SUBJECT: ISSUANCE OF AMENDMENT NO. 62 TO FACILITY OPERATING LICENSE
NO. NPF-21 - WPPSS NUCLEAR PROJECT NO. 2 (TAC NO. 67538)

This amendment revises limiting conditions for operation and instrumentation setpoints in the technical specifications to allow the operation of WNP-2 up to a power level of 75% power with one recirculation loop operating to the design burnup of the reload fuel of 35,000 MWD/MT bundle outage. The amendment makes revisions to related sections of the technical specifications to improve clarity. The amendment adds a new section on power/flow instability and moves the specification addressing flux noise from the section on instrumentation (Section 3/4.3) to the section on power distribution limits (Section 3/4.2).

SAFETY EVALUATION BY THE OFFICE OF NUCLEAR REACTOR REGULATION
SUPPORTING AMENDMENT NO.62 TO FACILITY OPERATING LICENSE NO. NPF-21
WASHINGTON PUBLIC POWER SUPPLY SYSTEM
WPPSS NUCLEAR PROJECT NO.2
DOCKET NO. 50-397

Figure 3.2.1-3

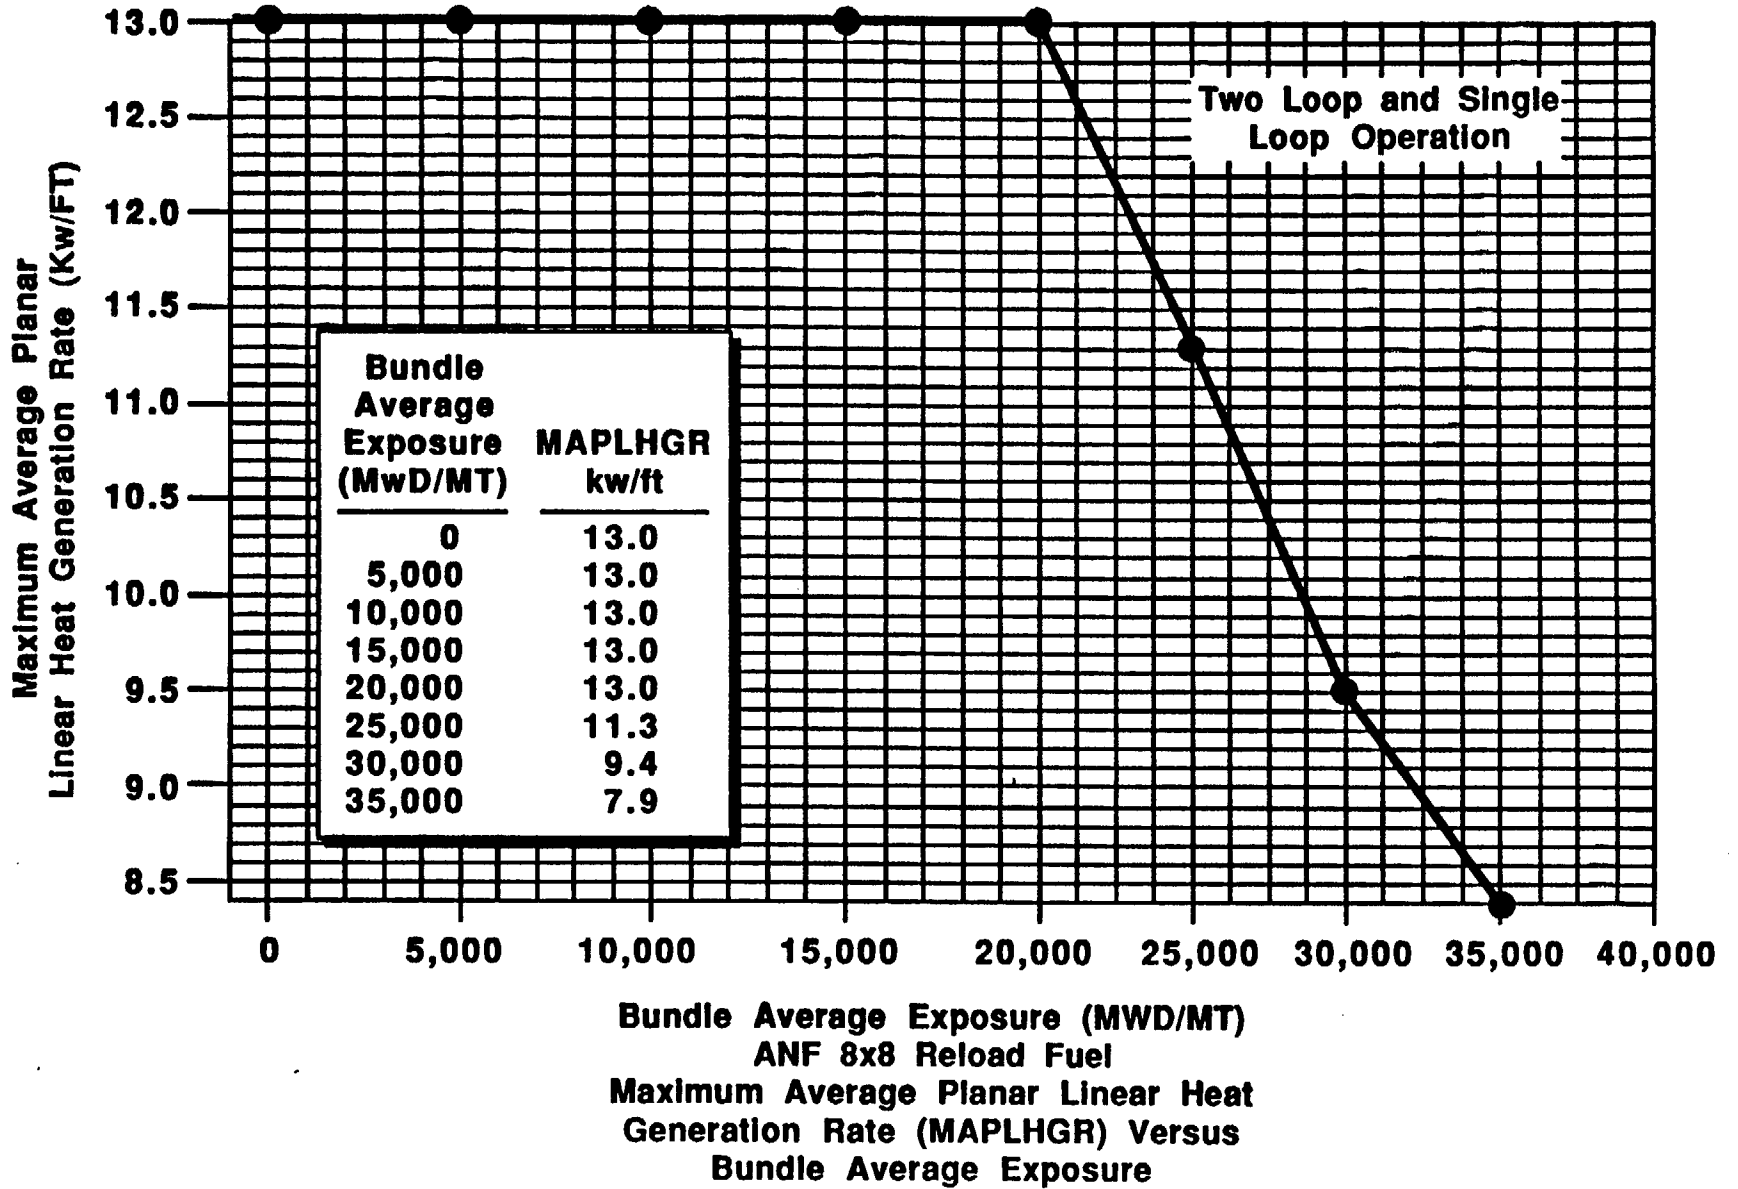
- (2) Specification 3/4.2.1: Figure 3.2.1-3 has been revised to include SLO. These MAPLHGR limits are not impacted by the small enrichment change associated with ANF fuel loaded for Cycle 4. In addition, for SLO these limits also apply to ANF fuel consistent with the flow dependent MCPR curve (1.35 at 50% of rated flow). The change is, therefore, acceptable.

**Reduced Flow MCPR Operating Limit
Figure 3.2.3-1**

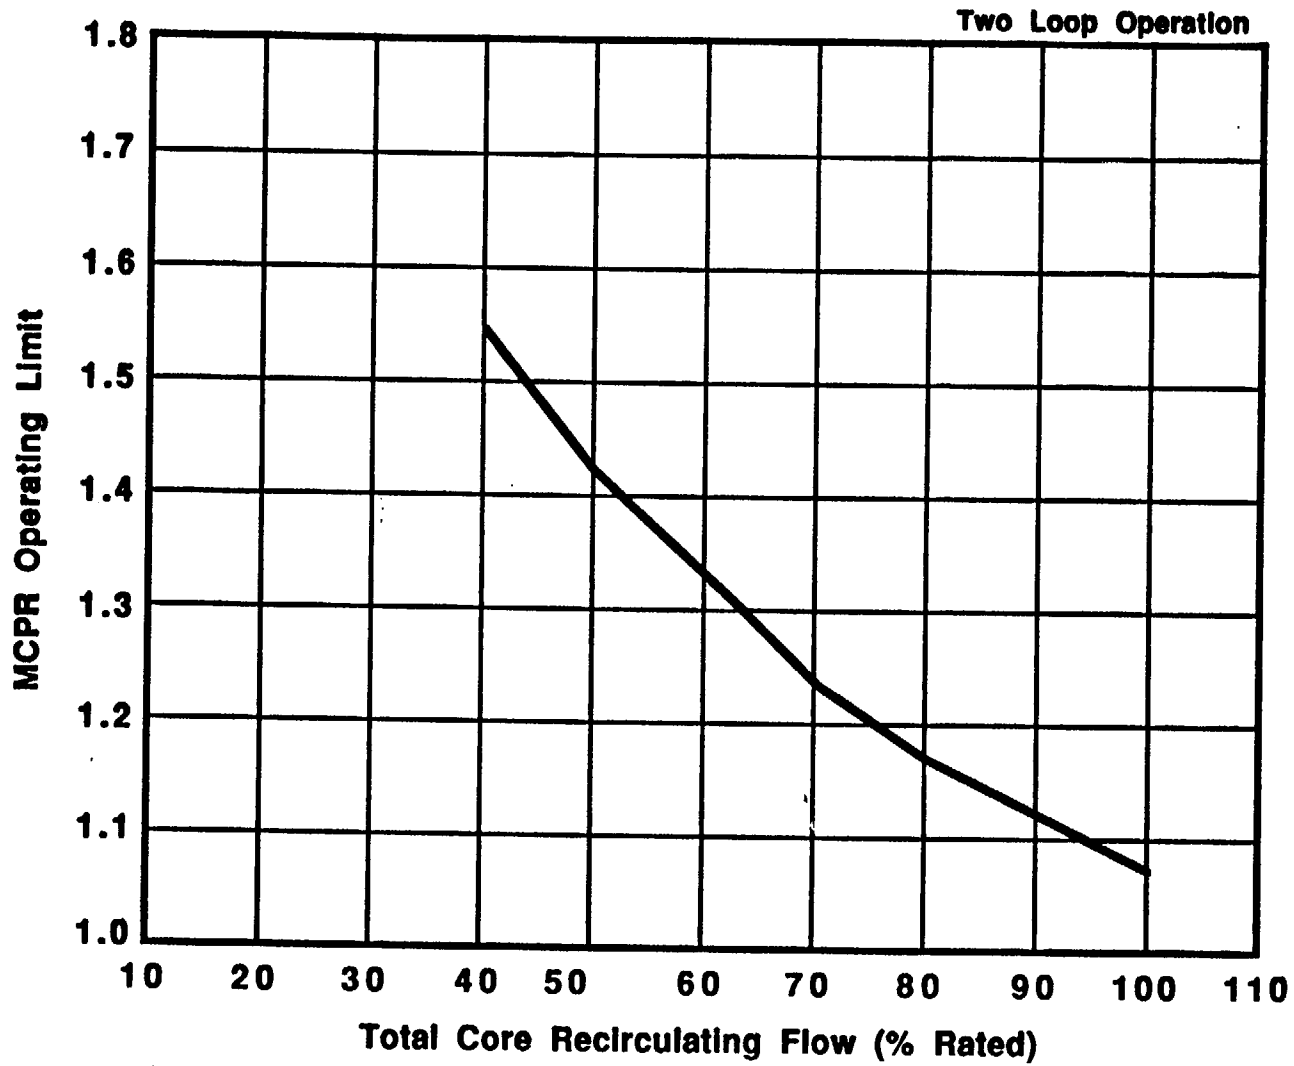
- (4) Specification 3/4.2.3: Table 3.2.3-1 and Figure 3.2.3-1 have been revised to reflect Cycle 4 MCPR operating limits. These new limits are based on the Cycle 4 reload safety analysis which has been evaluated and approved in Section 2 and are, therefore, acceptable.

Operating Region Limits of Specification 3.2.6
Figure 3.2.6-1

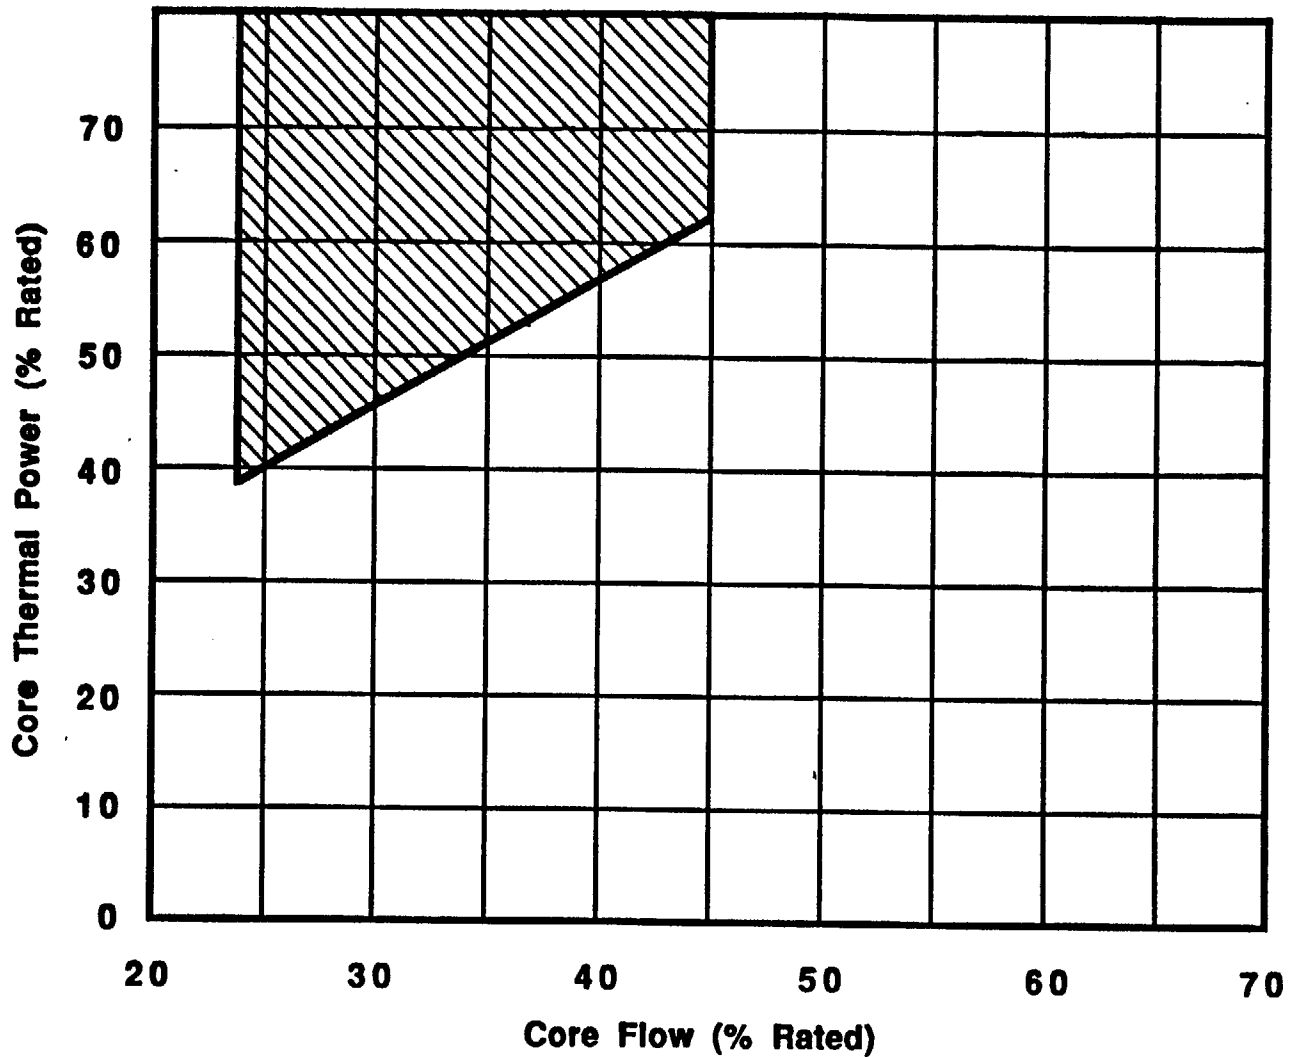
- (5) Specification 3/4.2.6: A new Section on Power/Flow Instability has been added. This was done to clarify the intent of action statement in existing technical specification 3.3.10. The power/flow operating map which was part of figure 3.3.10-1 is now Figure 3.2.6-1 and has been modified to bound future stability calculations. Based on the staff's evaluation of the stability analyses and surveillance requirements for Cycle 4, the proposed changes are acceptable.

3.2.6 Operation with THERMAL POWER/core flow conditions which lay in the crosshatched region of Figure 3.2.6-1 is prohibited.

Operating Region Limits of Specification 3.2.7
Figure 3.2.7-1

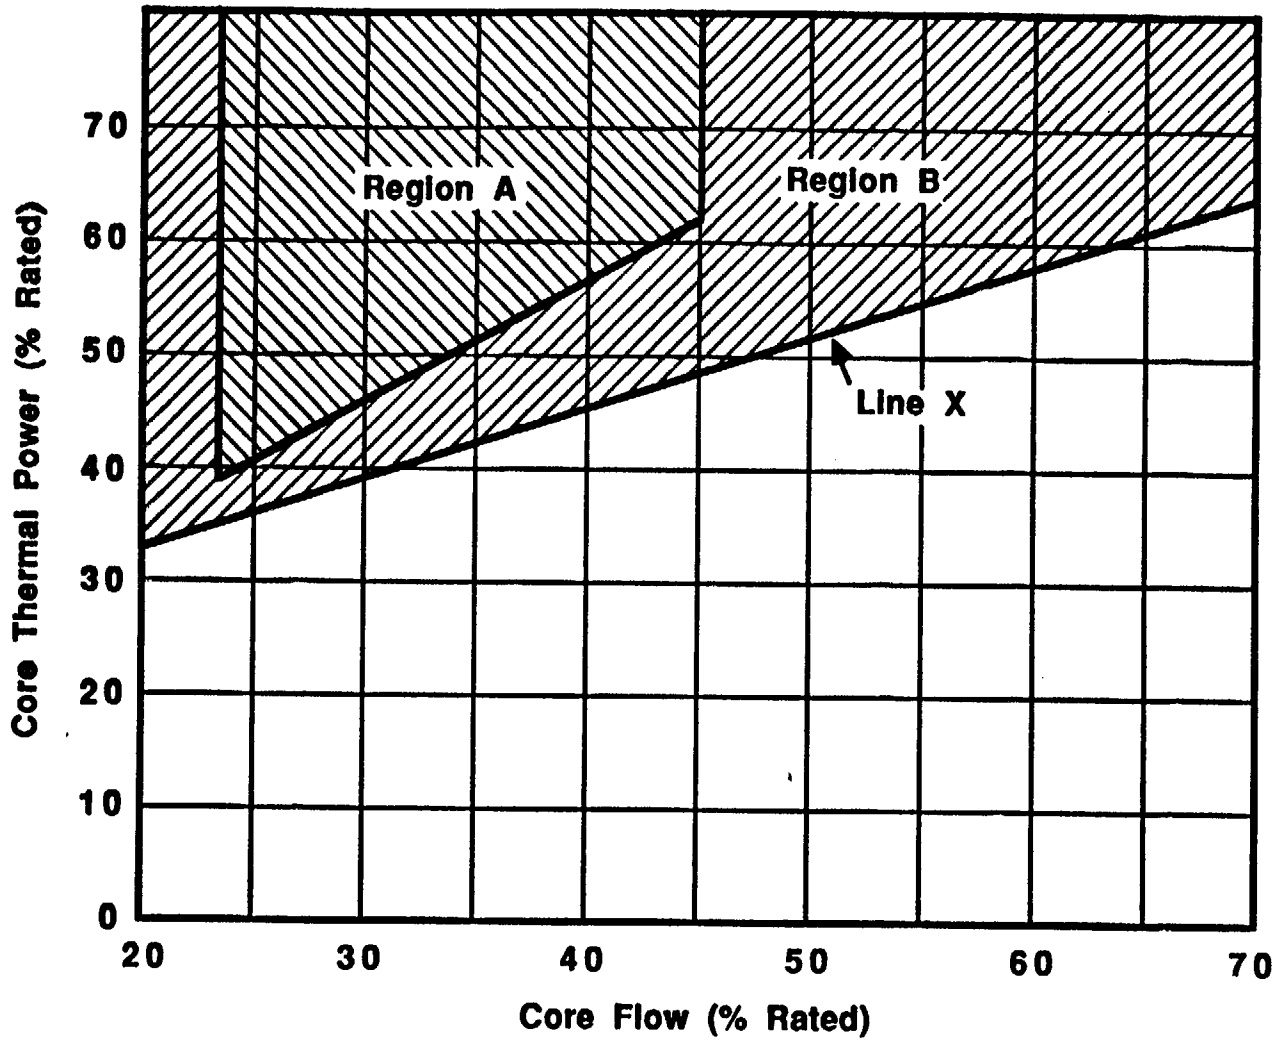
Specification 3/4.3.10 Neutron Flux Monitoring Instrumentation states that the APRM and LPRM neutron flux noise levels shall not exceed three times their established baseline values when operating in the allowable region of Figure 3.3.10-1. The action statement prescribes steps the licensee must take when the neutron noise flux noise levels do not meet the limiting condition for operation. The action statement further prescribes steps the licensee must take when reactor power and core flow fall outside of the allowable region of the figure. The licensee contends that this LCO and associated action statements constitute power distribution limits rather than instrumentation limits. It is proposed to move this to part 3.4.2 of the technical specifications and to include an LCO corresponding to each of the two parts of the action statement. The staff finds that since the limits are not changed there is no safety significance to this revision and it is, therefore, acceptable.

APPLICABILITY: OPERATIONAL CONDITION 1 with THERMAL POWER/core flow in Region B of Figure 3.2.7-1, with two reactor coolant system recirculation loops in operation and total core flow less than 45% of rated total core flow, or with one reactor coolant system recirculation loop not in operation.
